APPLICATION FOR SUBMITTAL OF POST-APPROVAL DOCUMENT

APPLICATION FOR SUBMITTAL OF POST-APPROVAL DOCUMENT

9 BIKE RACK

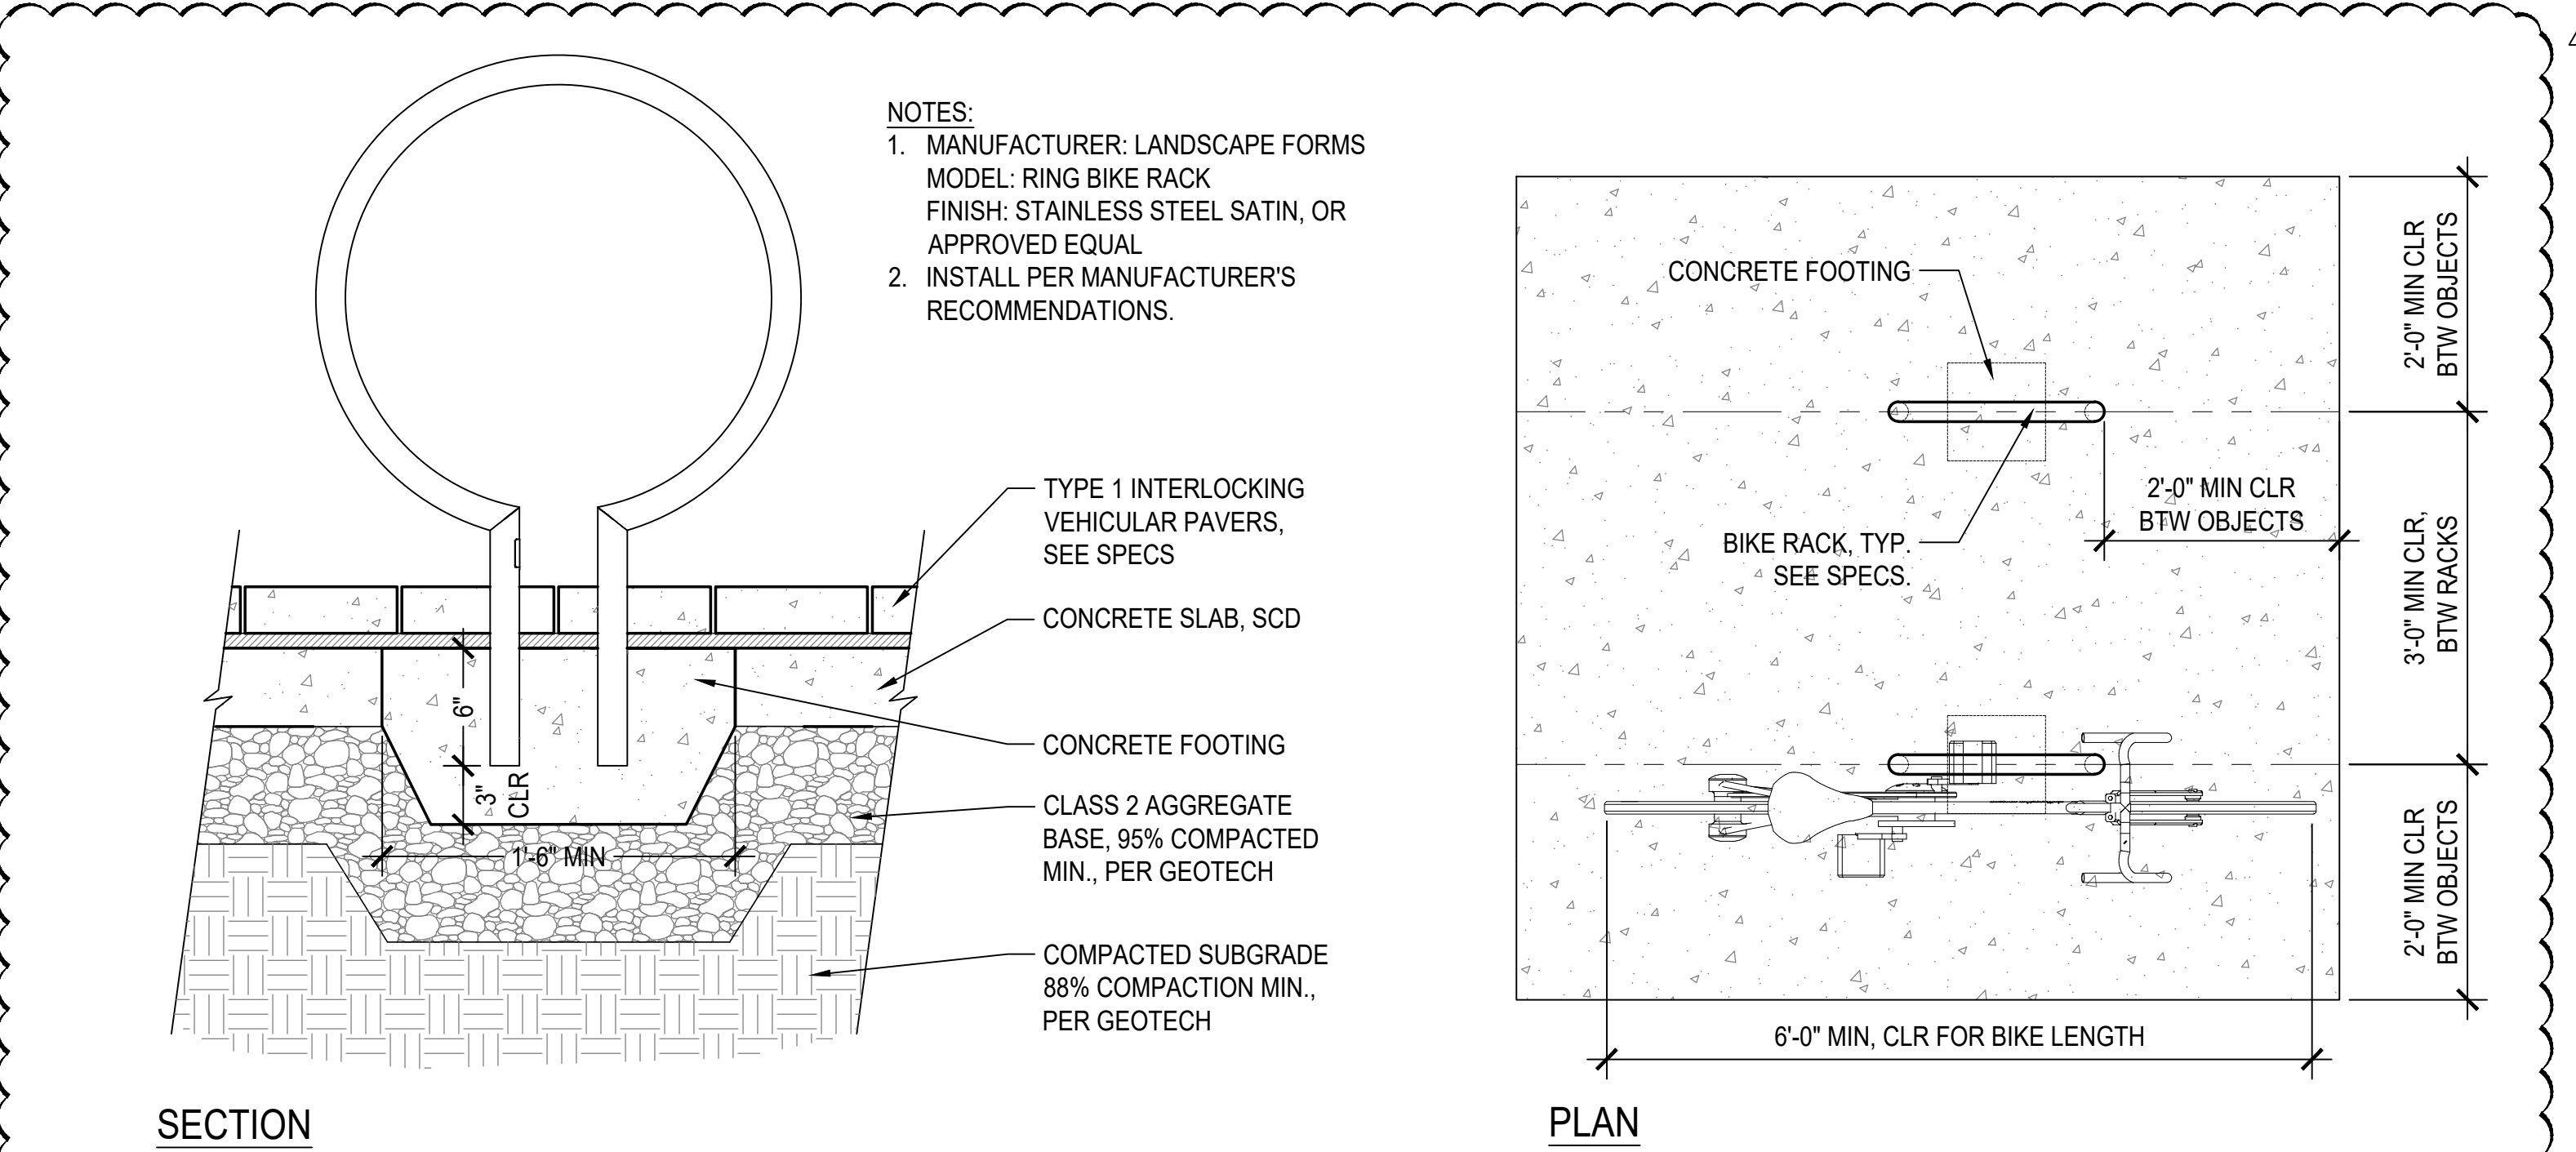
- ii. Callout & Schedule Note for “Gravel Surfacing” have been revised to “Stabilize Granite Paving”.
- j. **L4.0**
 - i. Detail 9/L4.0 Bike Rack has been added.

10. Sheet L3.0 calls out (4)four bike racks. Spec section Site Furnishings - 32 3300 paragraph 2.4 states "Per Campus Standard." Please provide these standards and how they are to be mounted whether in-ground or surface mount	RHAA	Please see Addendum #5, Detail 9/L4.0 Bike Rack for bike rack type and installation method. Bike racks are to be the Ring bike rack w/ stainless steel finish by Landscape Forms.

drawing no.:
A831

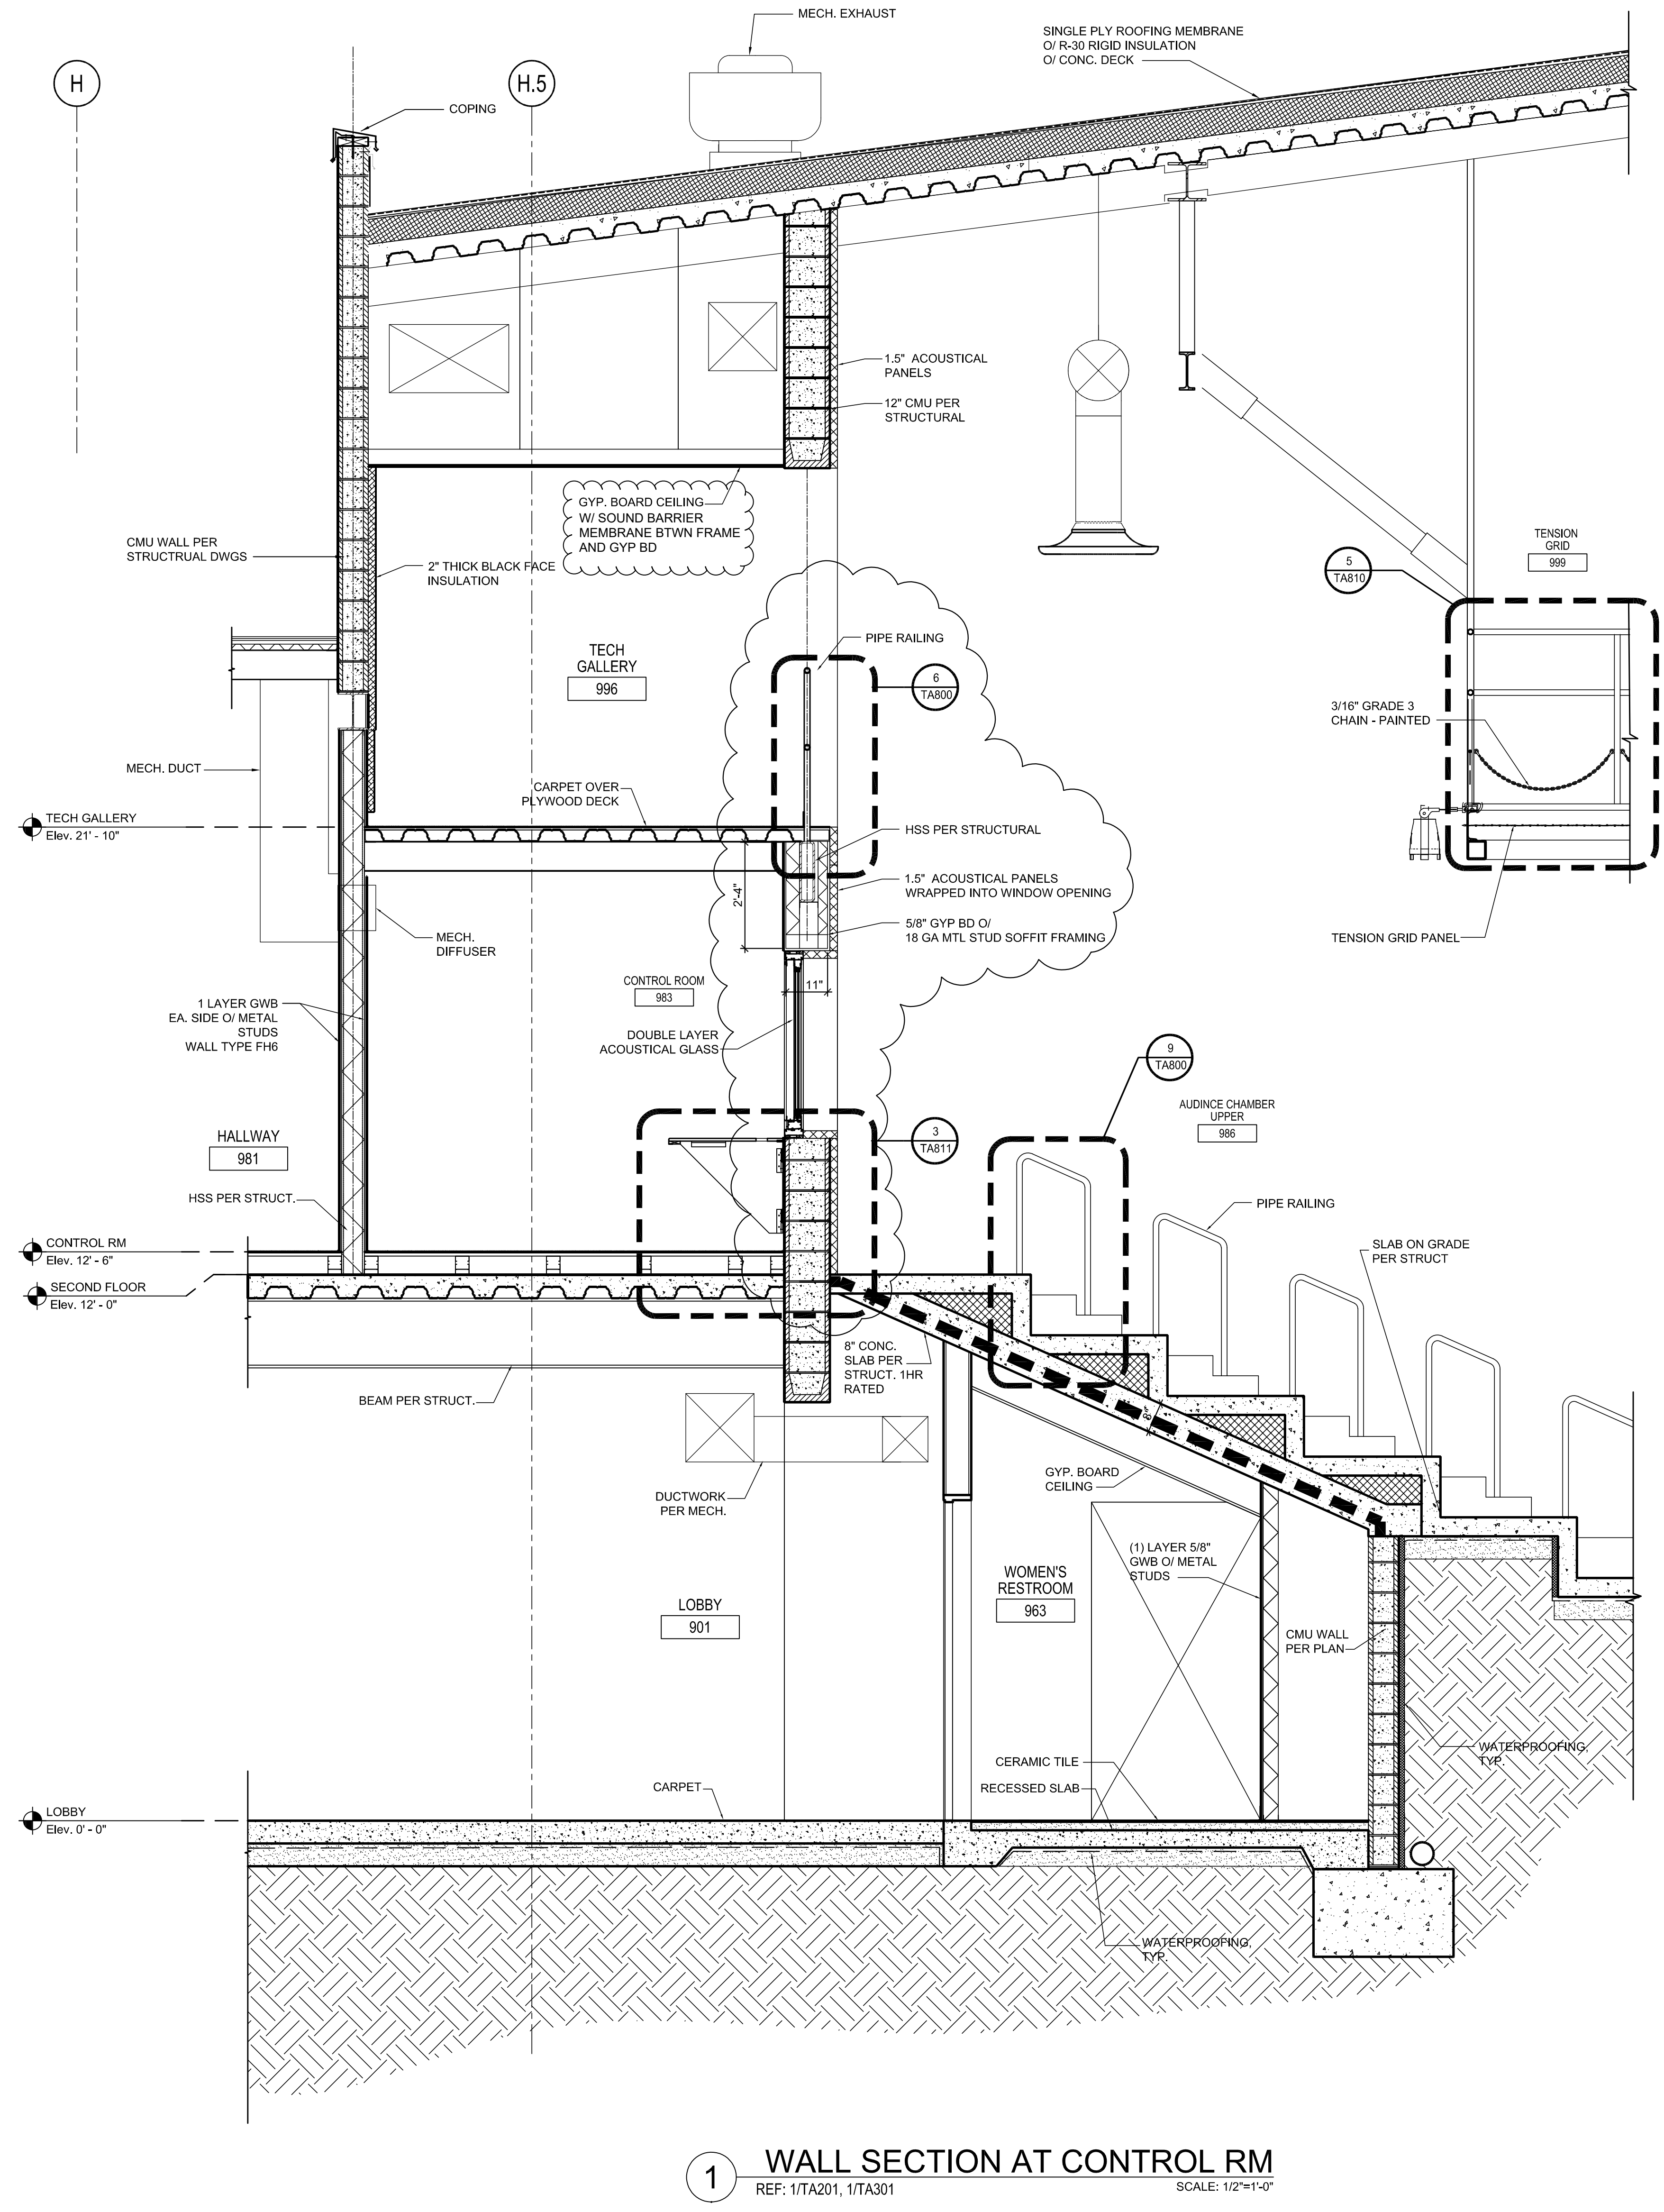
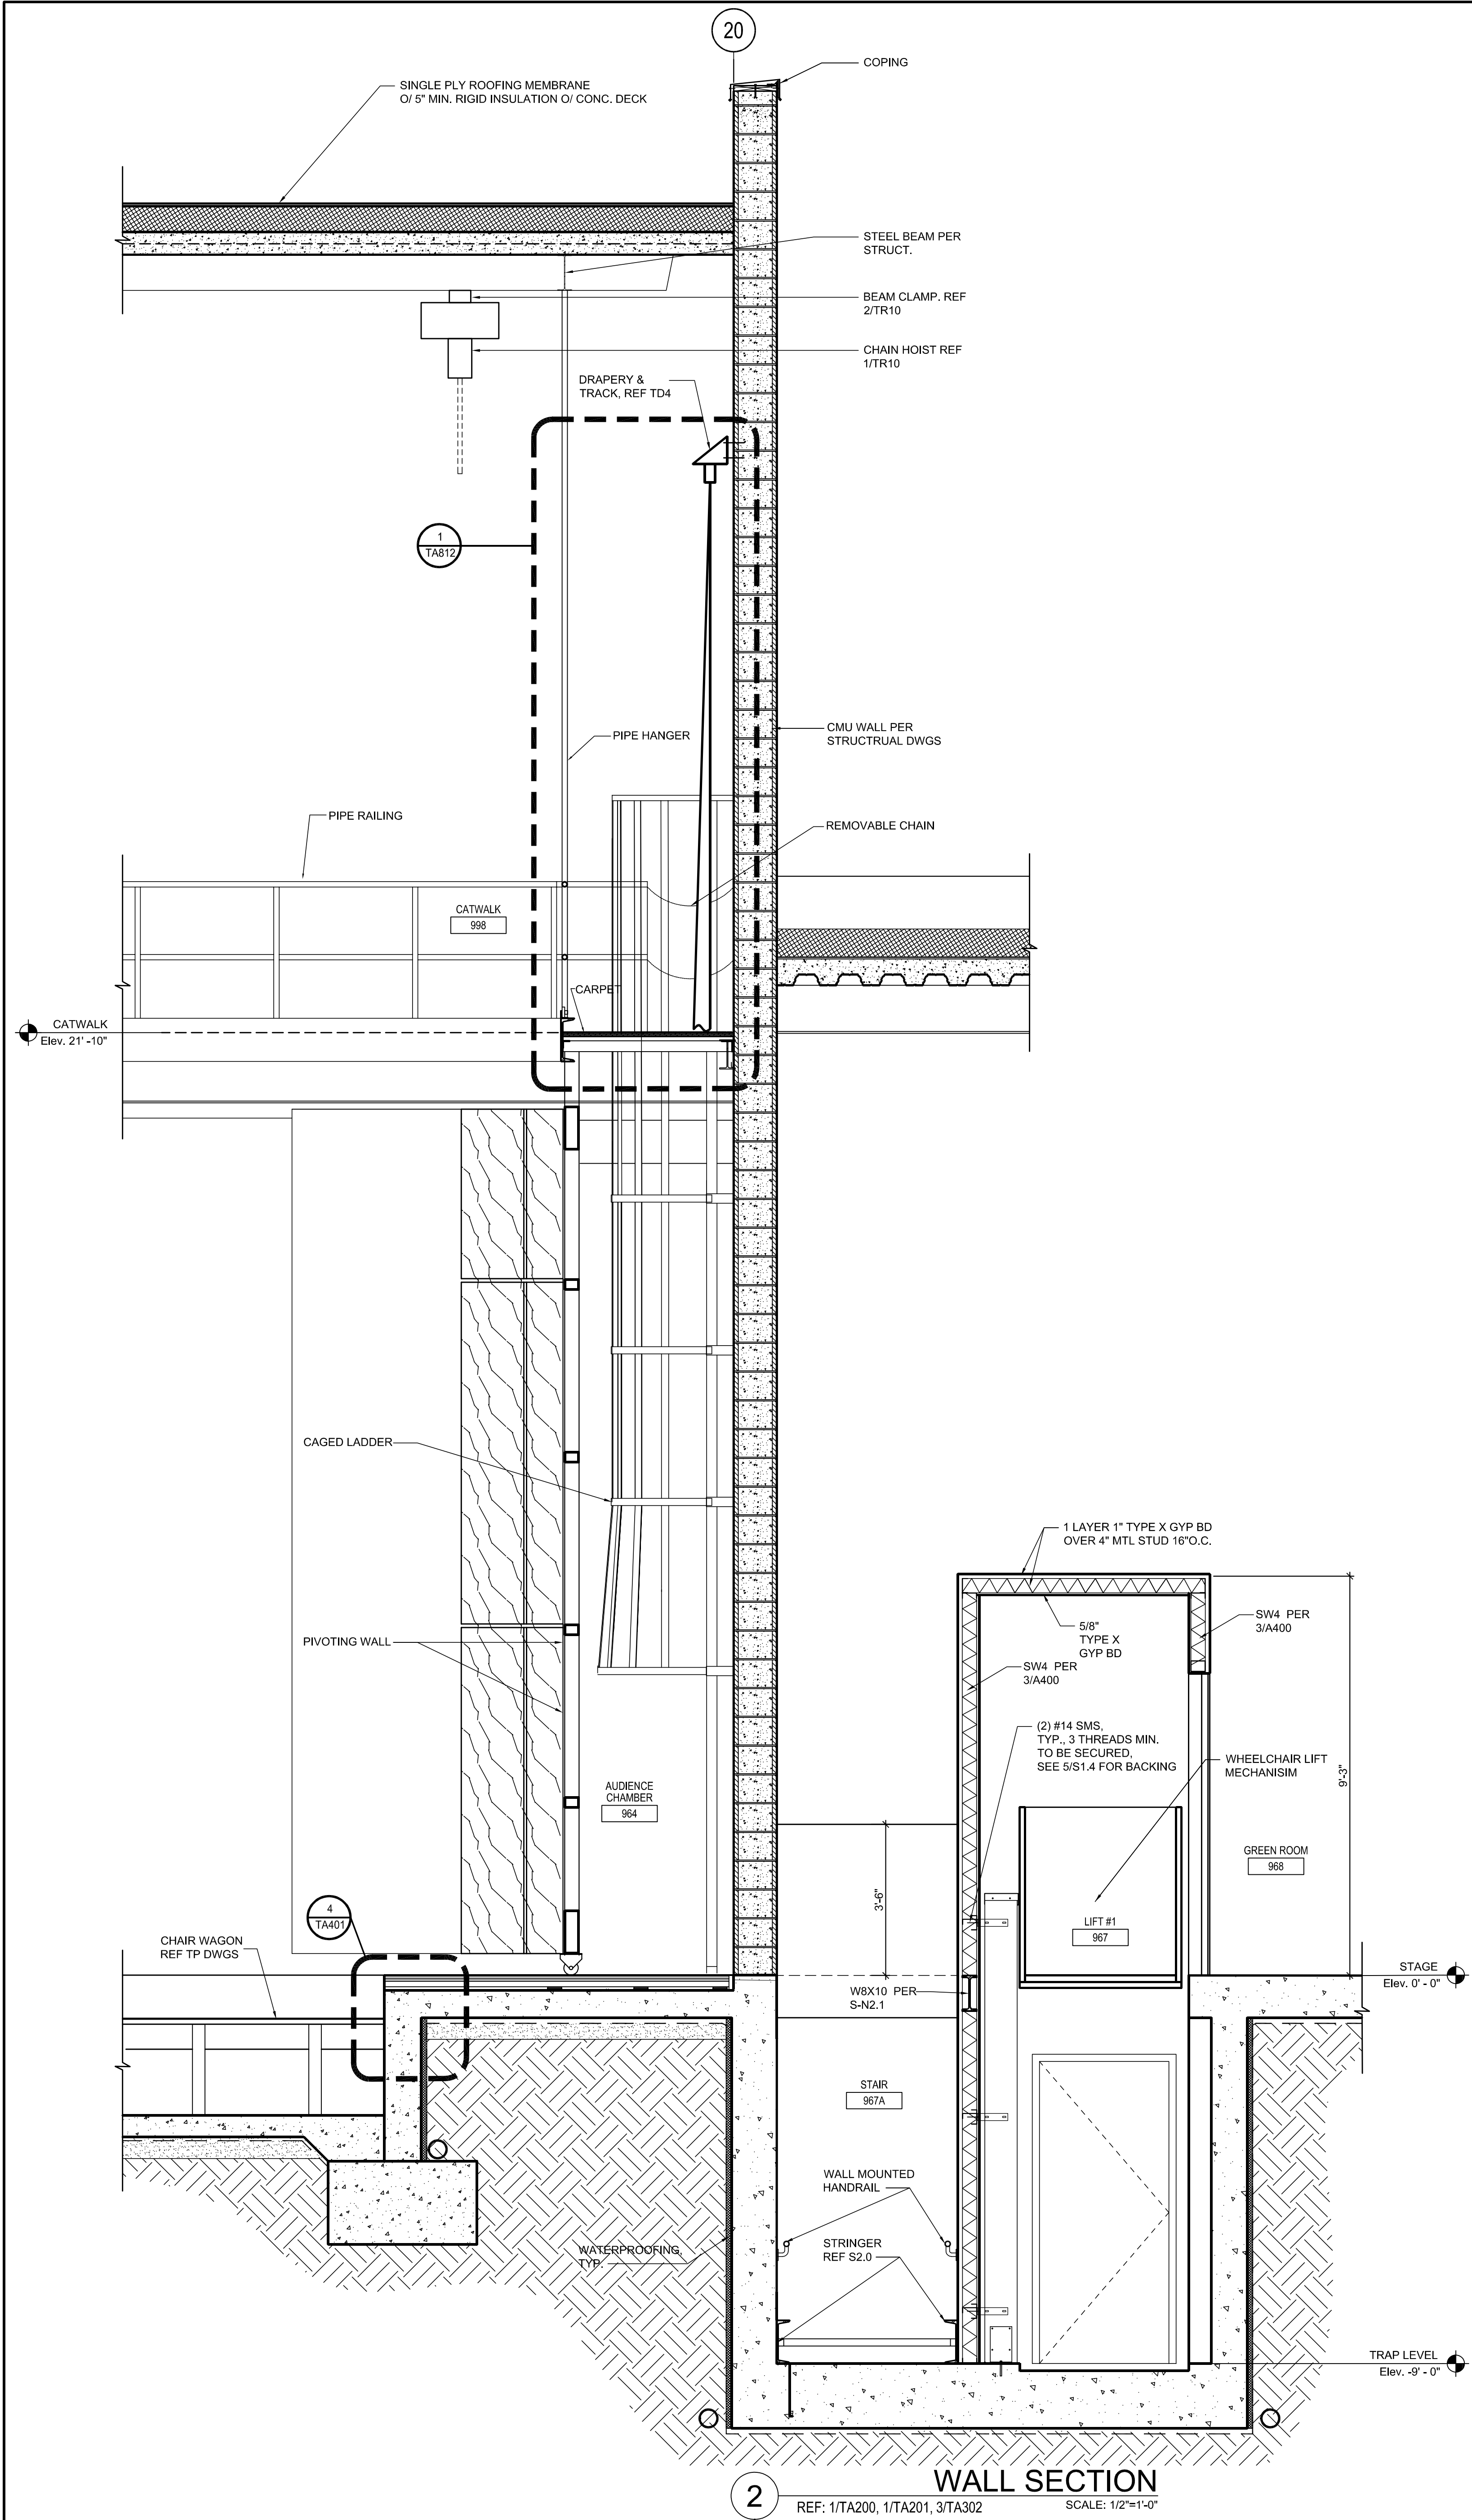
- o. **A831**
 - i. Detail 4- call out fire rated wood cap
 - ii. Detail 9- call out Preprufe 300r
- p. **TA 411 –**
 - i. Added sound barrier note
 - ii. Updated section to coordinate w/ structural

39.Waterproofing: Specification section 07 13 13 / 2.7.A calls for 1" expanded polystyrene protection board over the Bituthene 4000 sheet membrane waterproofing. Detail 9/A831 shows insulating drain board over the Bituthene, which we interpret as the Hydroduct Drain Panel per section 2.6.A. Is the protection board necessary over the drain board?	tBP	Provide Both Drainage & Protection Board, see revise detail 9/A831

12/15/21	Roebbelen	30. Concrete / Structure Backfill: Details A and B/S3.2 prescribe structure backfill at the Orchestra Pit with Lean (2-sack) Concrete. Per P201 there is drainage coincidental to the areas to be backfilled with lean concrete. Should we plan to apply detail 9/A831 with the lean concrete backfill above the drainage burrito? Does that influence the applicability of the Insulating drainage boards between the backfill and waterproofing per 9/A831?	ZFA/ tBP	See revised detail 9/A831.
